**Car Stereo  
Service Bulletin**

**Model:** XE-90

**No. 158**

**Subject:** Service Manual Correction - Page 12 **Date:** February 2, 1990

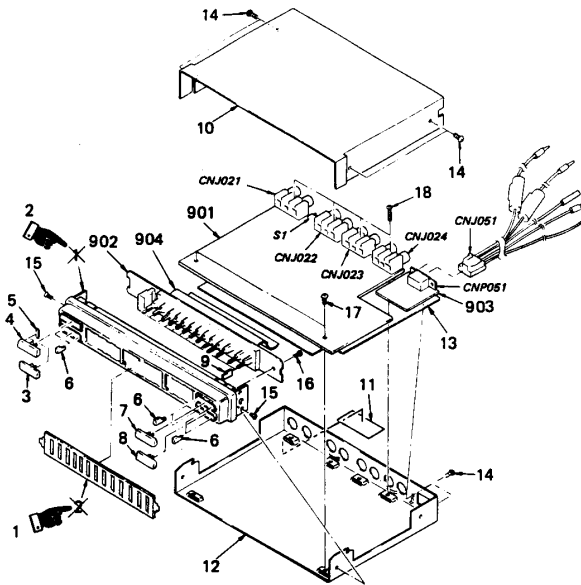
The exploded view has Reference Numbers 1 and 2 reversed.  
The Parts List is correct.

**Solution:** Please make the correction to the diagram as shown below:
